CITY OF PORT LAVACA

SUBJECT: **CONSIDER APPROVAL OF CHANGE ORDER NO. 4 TO THE WATER
SYSTEMS IMPROVEMENT PROJECT**

**Re: Letter of Recommendation of Approval of Change Order No. 4
Water Supply System Improvements
ARPA No: 2303
AECOM Project No. 60659778**

Change Order Number: 4

CIVIL
 PROPOSED OVERALL SITE PLAN

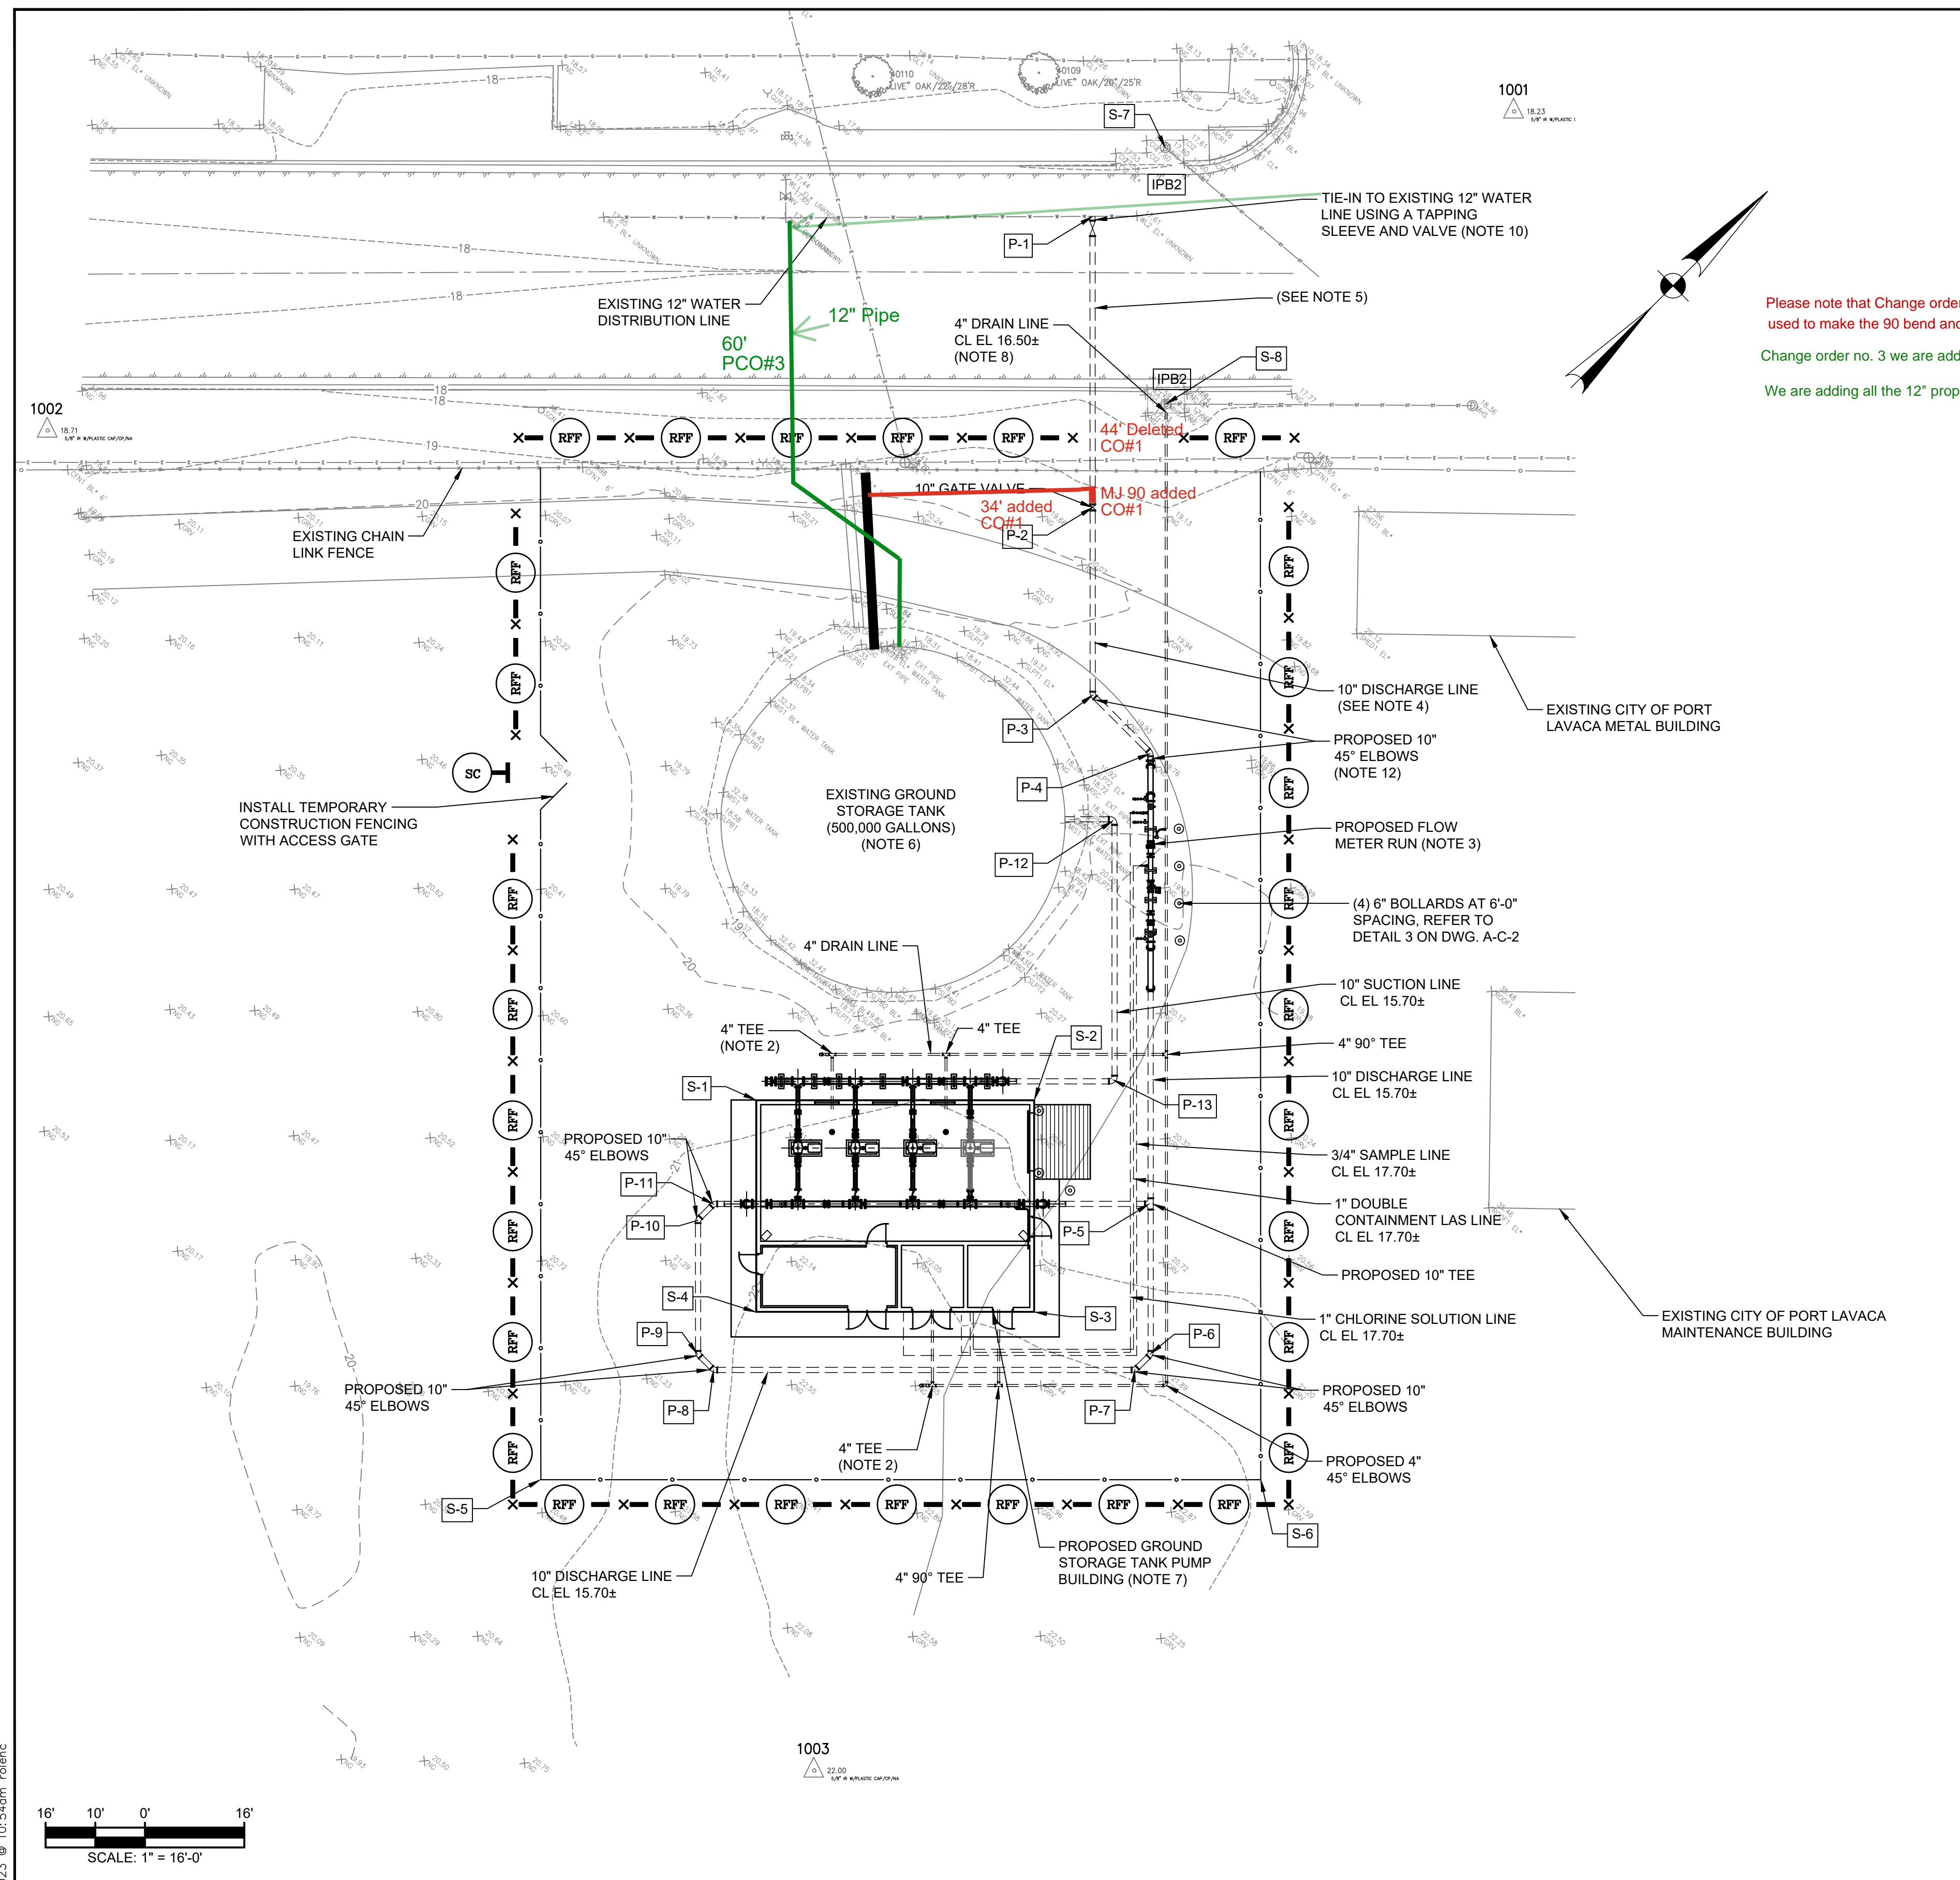
1. PROVIDE APPROPRIATE RESTRAINTS ON ALL TEES, WYES, BENDS, CROSSES, VALVES, AND OFFSETS PER PIPING SCHEDULE NOTE 12 ON DWG. NO. B-G-2.
2. PROVIDE CLEAN-OUT ON ALL ELBOWS AND TEES ON DRAIN LINE. REFER TO DETAIL 7 ON DWG. A-C-2 FOR CLEAN-OUT DETAIL.

3. REFER TO DWG. NO. B-M-6 FOR METER RUN PLAN AND SECTIONS.
4. CENTERLINE ELEVATION OF EXISTING 12" WATER DISTRIBUTION LINE TO BE DETERMINED BY CONTRACTOR. CENTERLINE OF PROPOSED 8" DISCHARGE LINE TO MATCH CENTERLINE OF EXISTING DISTRIBUTION LINE. PROVIDE A MINIMUM OF 4'-0" OF COVER ABOVE THE PIPE WHERE POSSIBLE.

Please note that Change order no 1 a credit of \$ 30,000 was issued. The pipe which extended to the existing waterline was used to make the 90 bend and tie in to the existing fill line. No pipe line was credit. Only the work outside the fence was credit
Change order no. 3 we are adding the work outside the property and Therefore \$ 30,000 must be added back to the Change order in addition
We are adding all the 12" proposed pipe line This is considered all new pipe and materials.

CHANGE ORDER 1

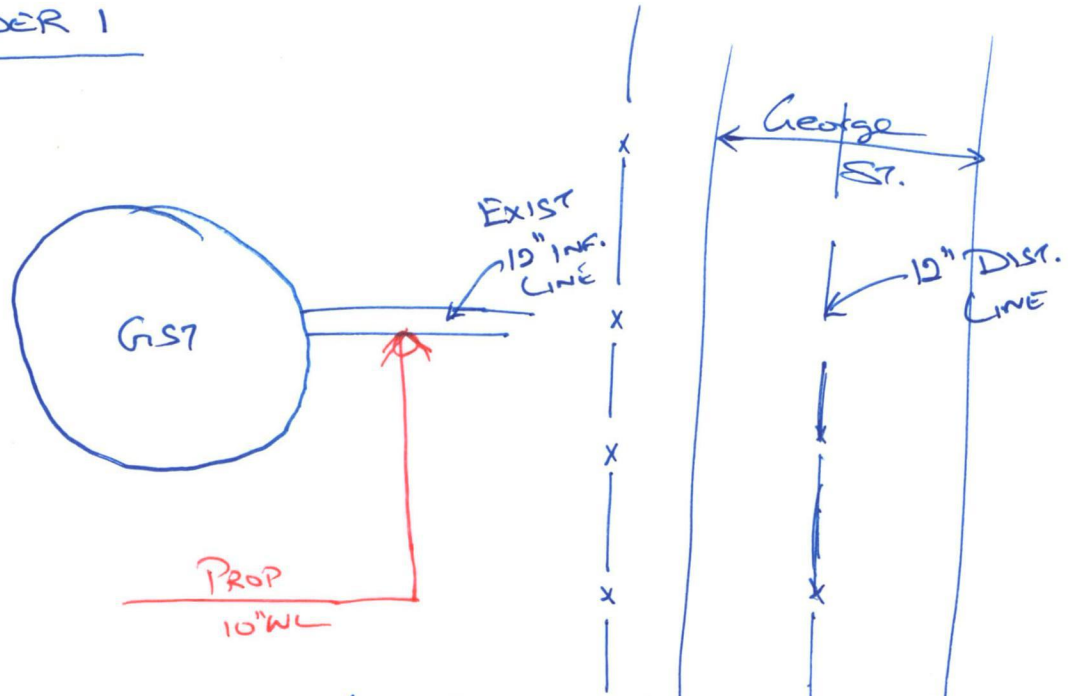
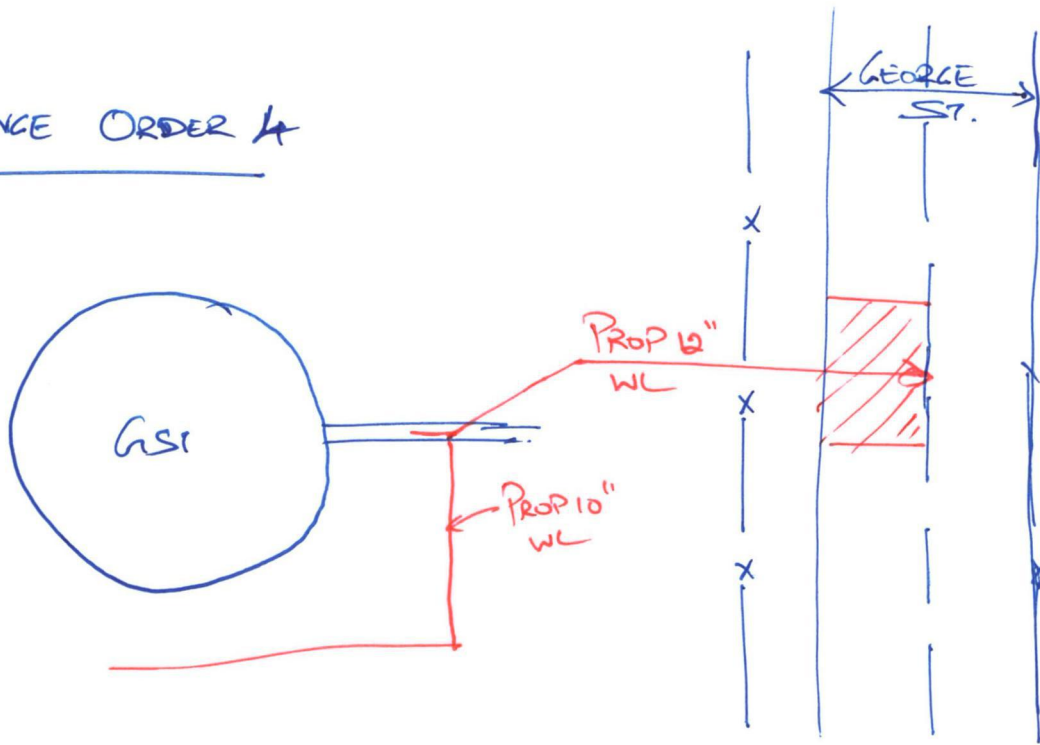
Understanding was that the Exist 12" Influent Line is connected to the distribution system (12" line along George Street)
Eliminates portion of proposed 10" WL
Eliminates replacement of pavement (George St) at the TSV location

Found out that the Exist 12" Inf Line is not connected to the distribution system and that it comes from remote site

- Added charges for labor and materials for removing existing waterline and installing new waterline (\$4,419)
- Added charges for new waterline pipe and equipment (\$12,478)
- With Labor Burden (55%), Overhead(10%), Profit(5%), Bond(2.5%), and Insurance(1.5%): \$23,000
